CITY OF MISSION, KANSAS
COMMUNITY DEVELOPMENT COMMITTEE

WEDNESDAY, APRIL 4, 2018

RE: Tidal Wave Auto Wash Preliminary and Final Site Plan, 6501 Johnson Dr

STAFF REPORT
Planning Commission Meeting March 26, 2018

1194 SF WALL SURFACE EXCLUDING GABLES, ROOF, CUPOLA, & OPEN BAYS
805 S.F. GLAZING (WINDOWS)
261 S.F. STONE
128 S.F. SPLIT FACE BLOCK (WATERTABLE)

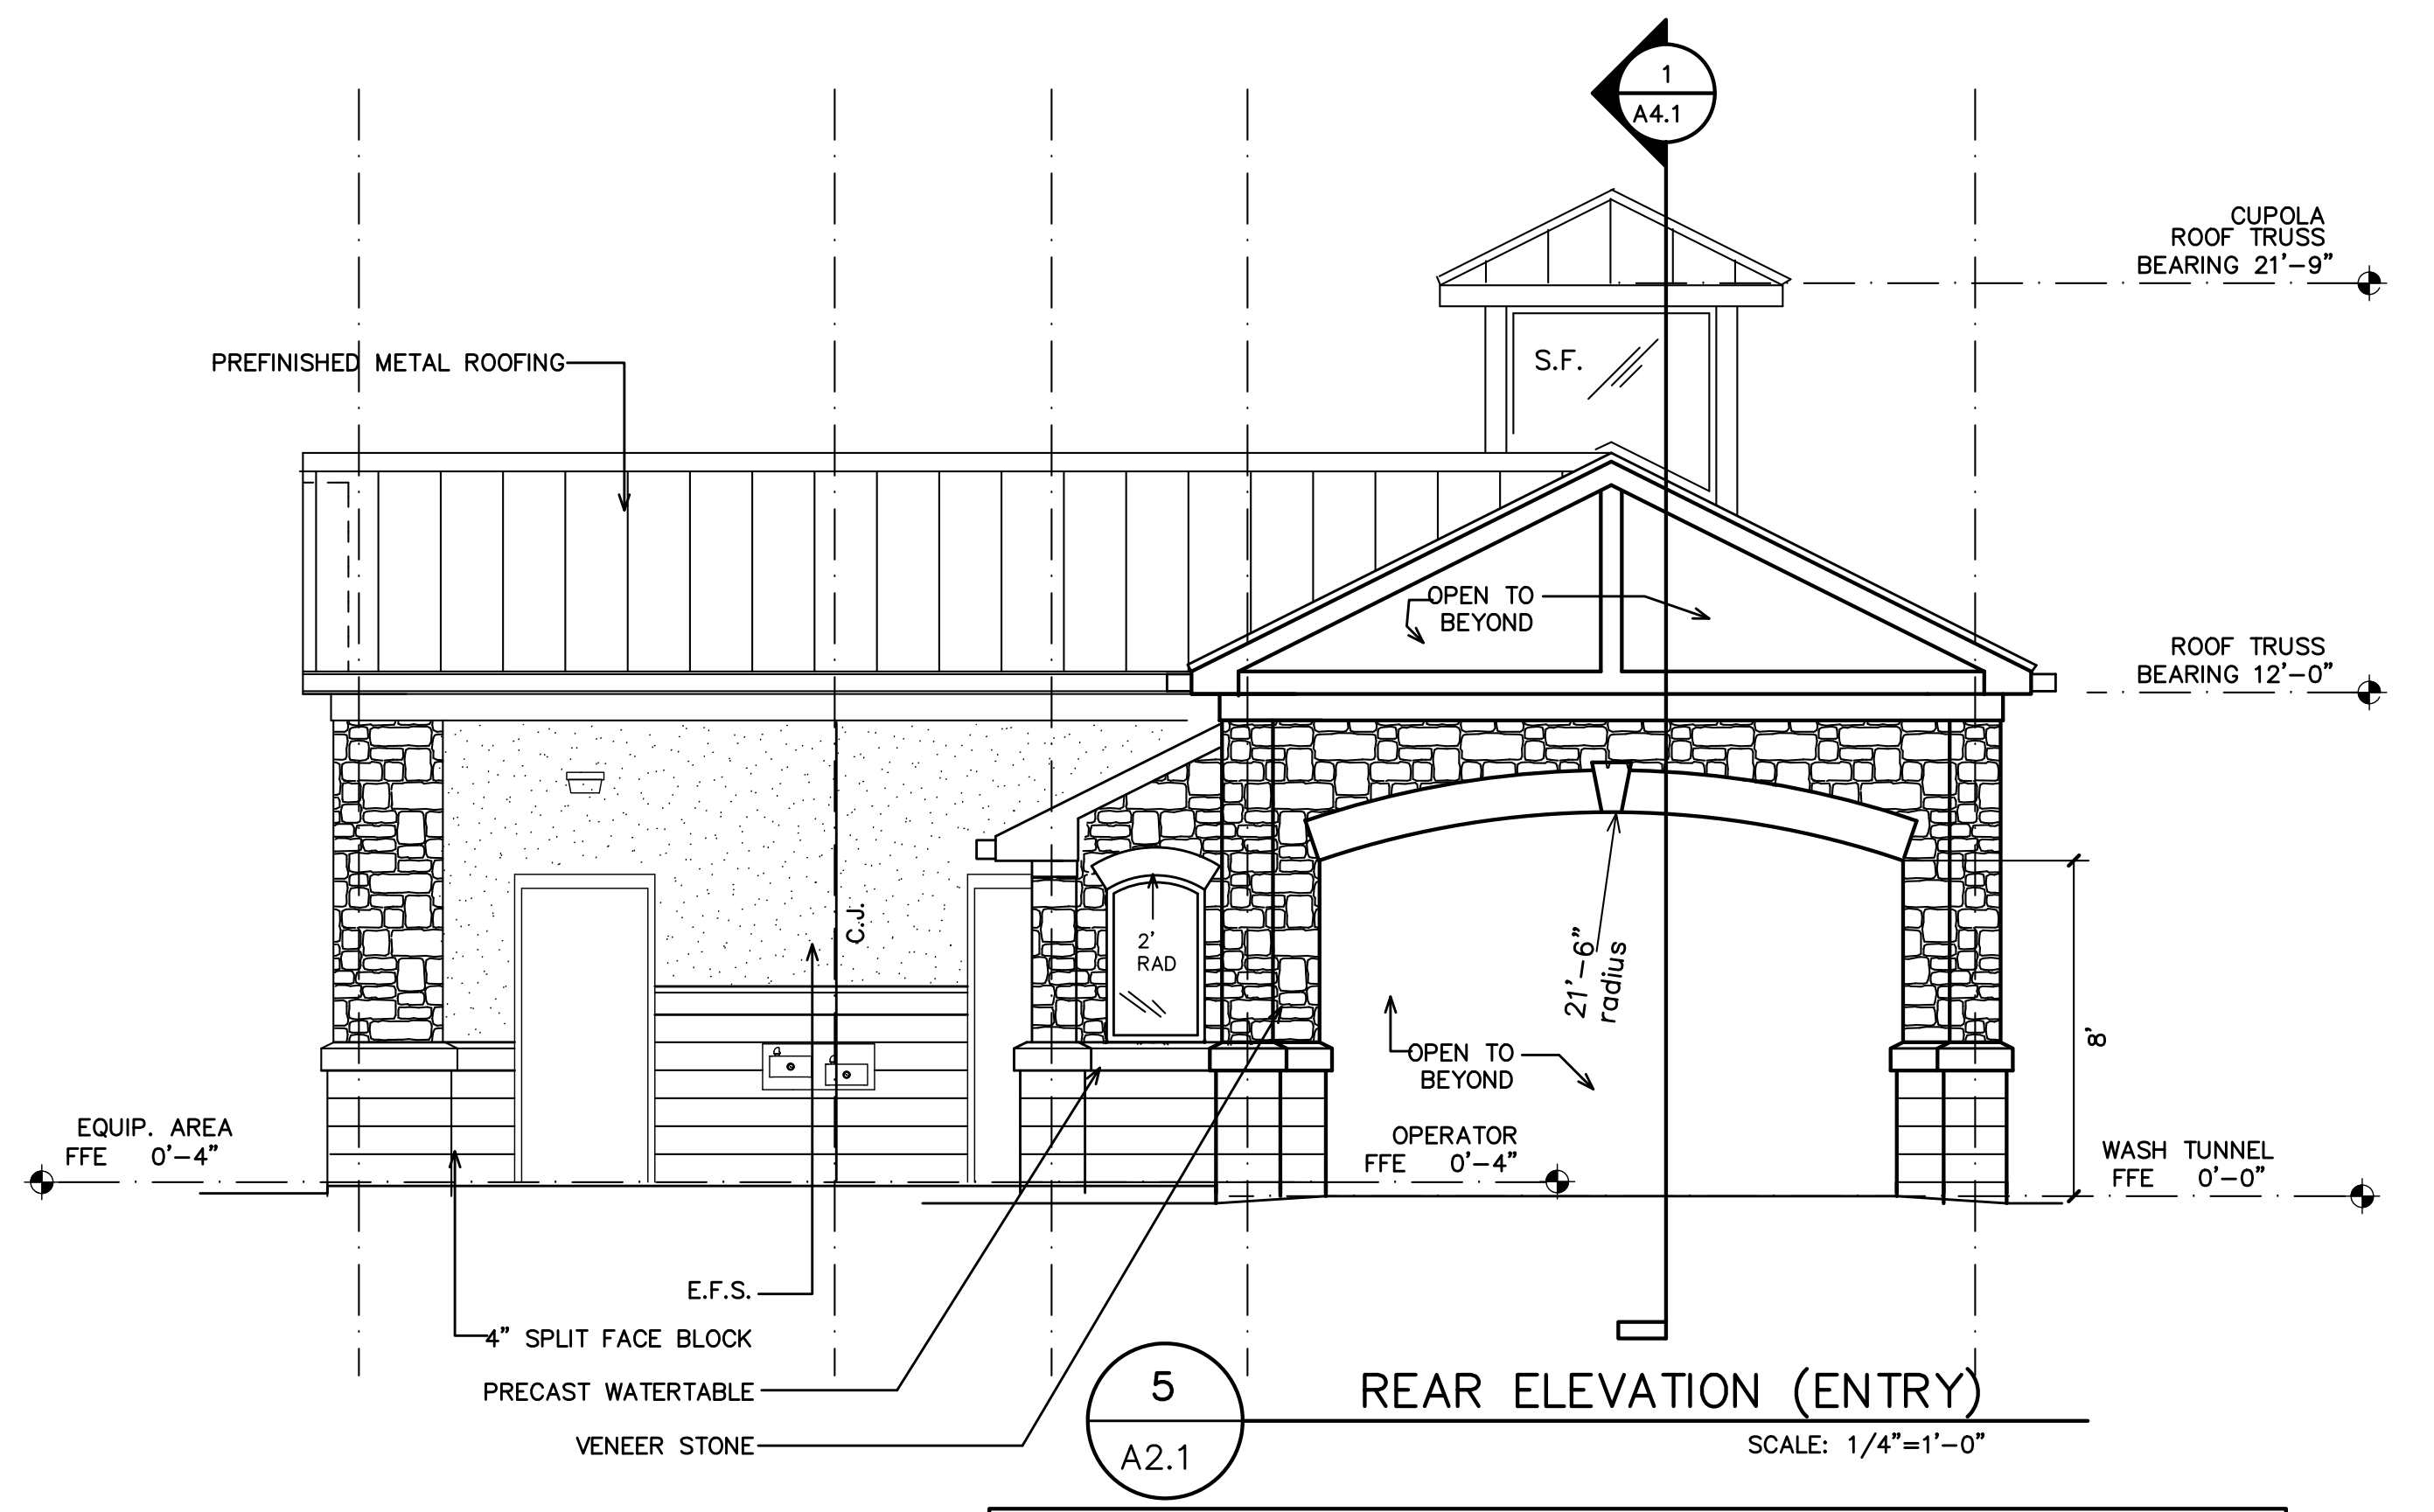
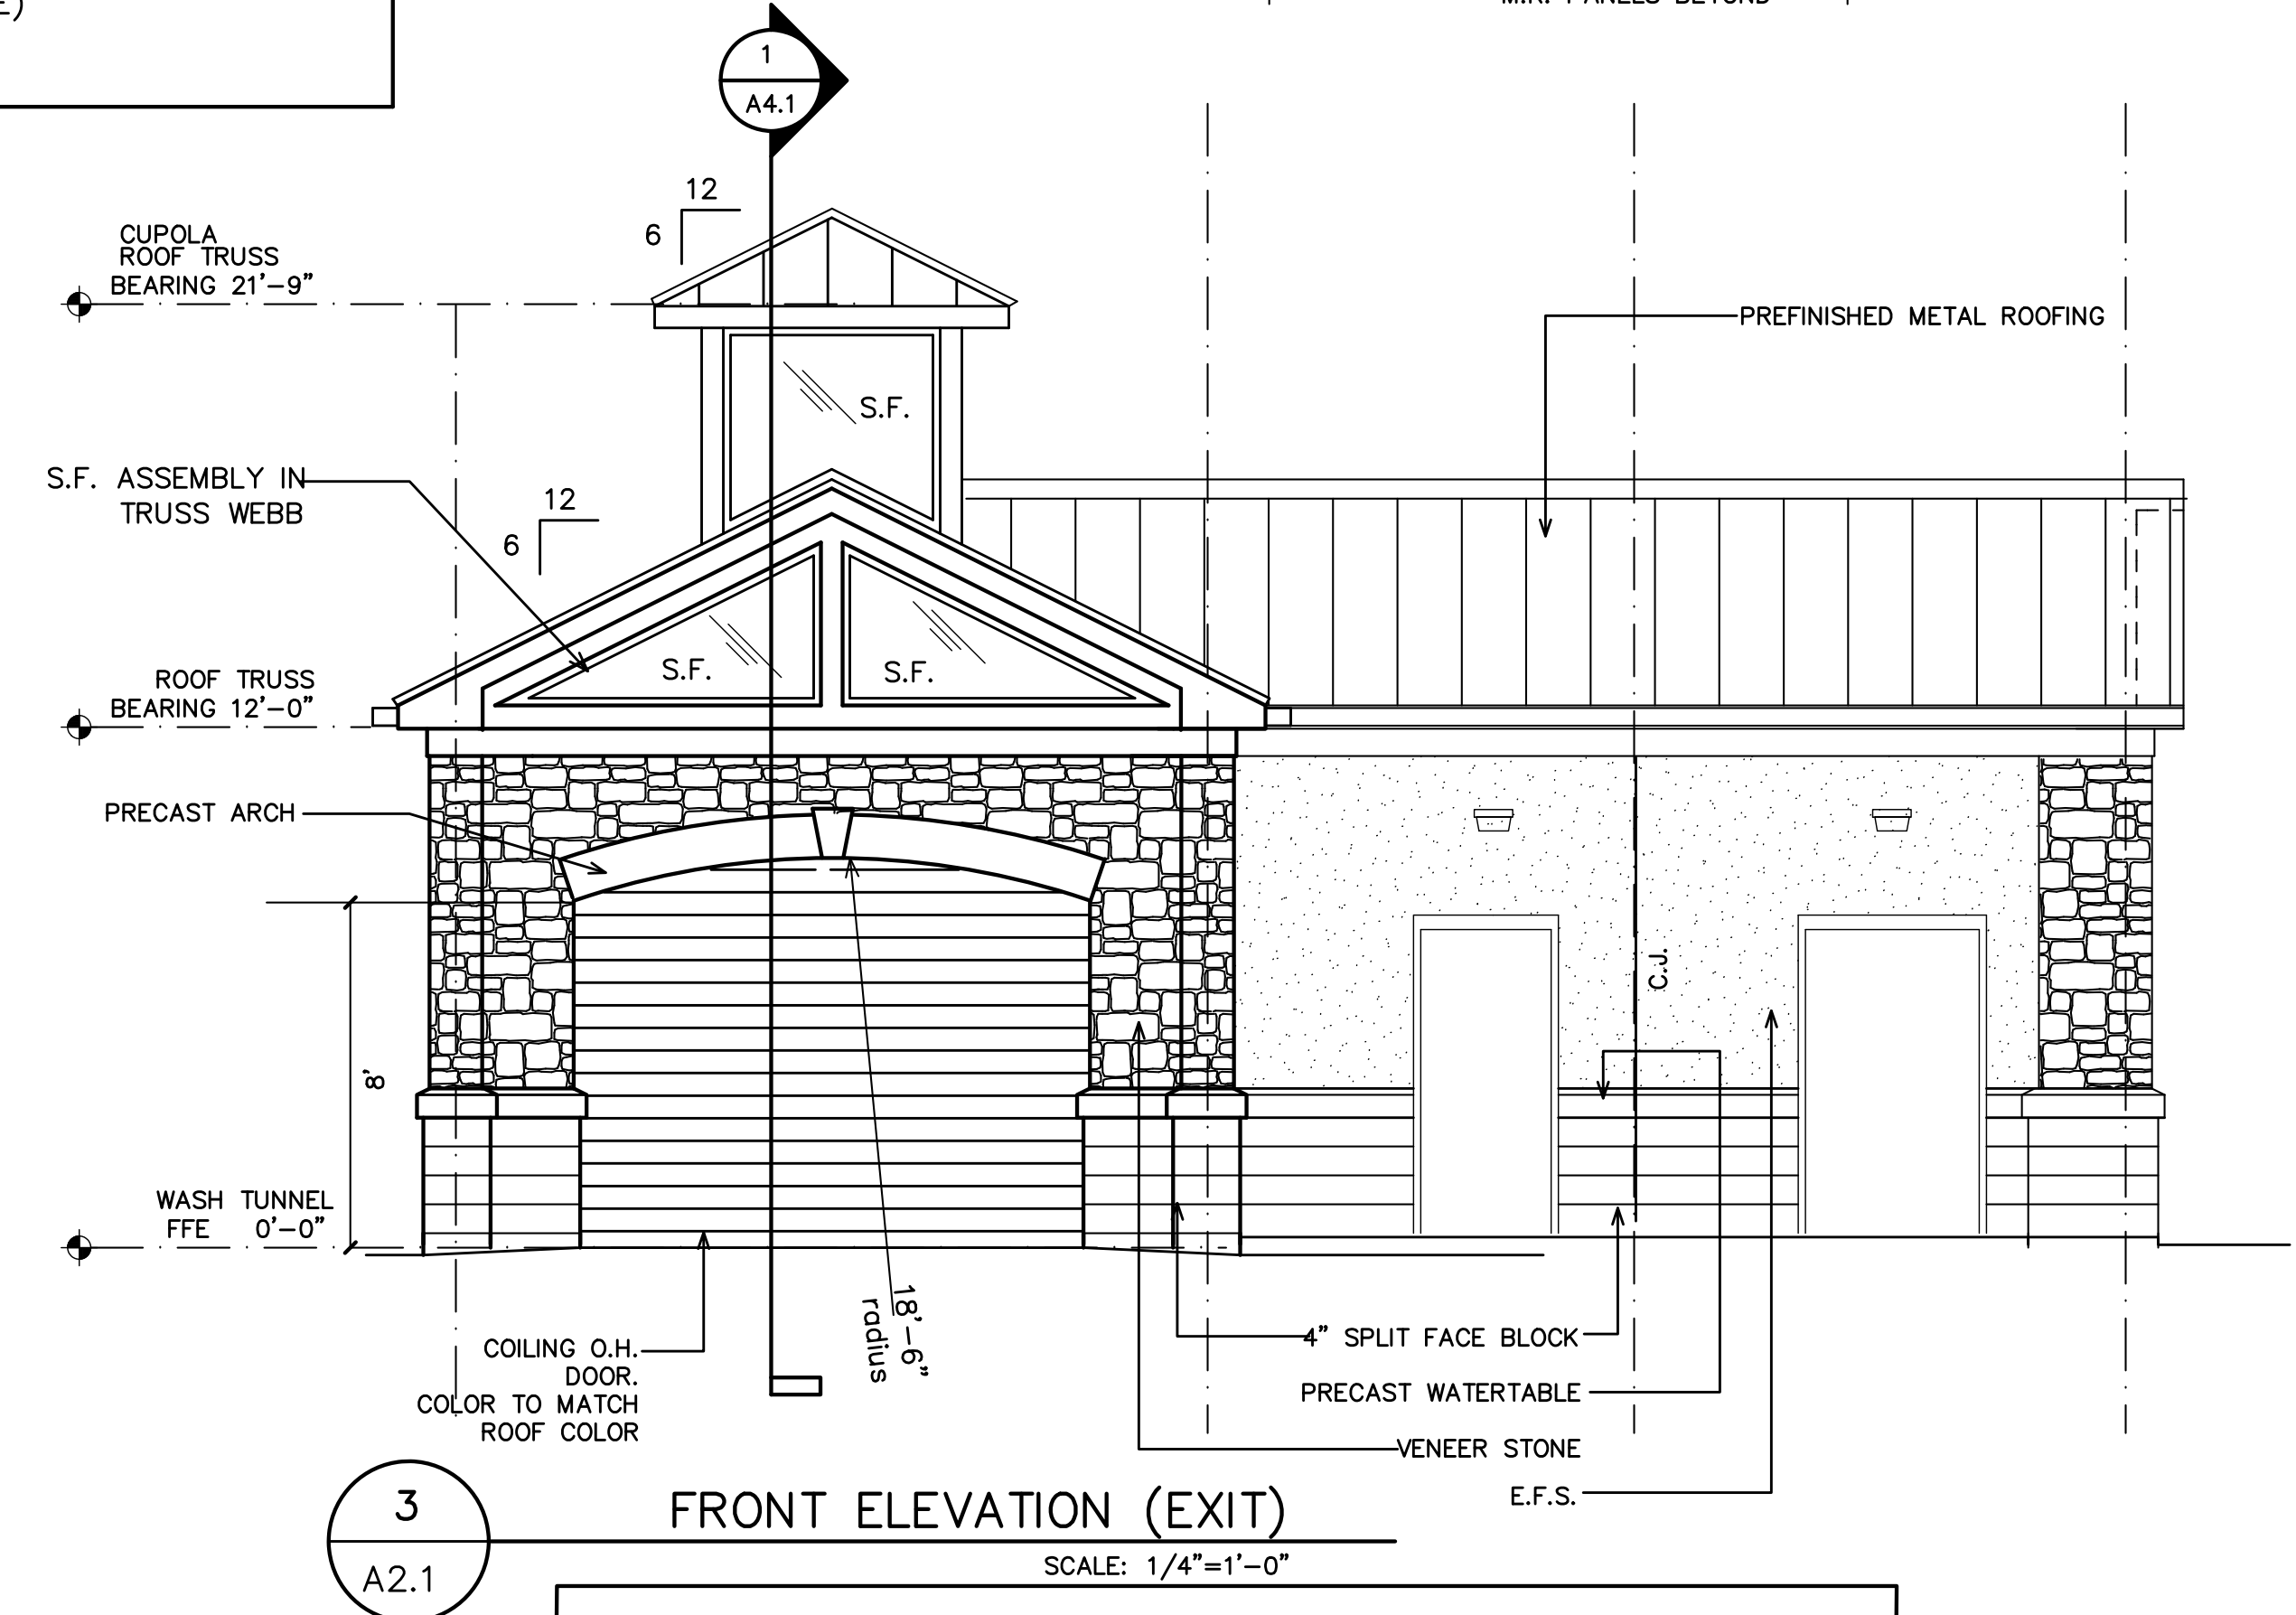
Due to the aforementioned one-story structure not meeting the required 26' building height to be considered a Low-Rise building type, the taller structure not meeting the definition of a Parking Structure building type, and the material comments outlined above, the full score for this portion of the plan review has not been achieved. This can be rectified by the applicant revising the design and providing additional details for these structures to comply with the intent of the FBC building type and architectural treatment requirements.
Score: 2.5/6 points

For these reasons, the full score for this portion of the plan review has not been achieved. This can be rectified by the applicant revising the elevations of these proposed structures, walls, and railings (if any are needed for safety) to reflect proposed materials and finishes, and by submitting samples of these materials for review.

- Provide calculations indicating windows and doors of commercial establishments occupy no less than 60% of the total storefront, from sidewalk grade to a distance of 18' above the sidewalk grade.
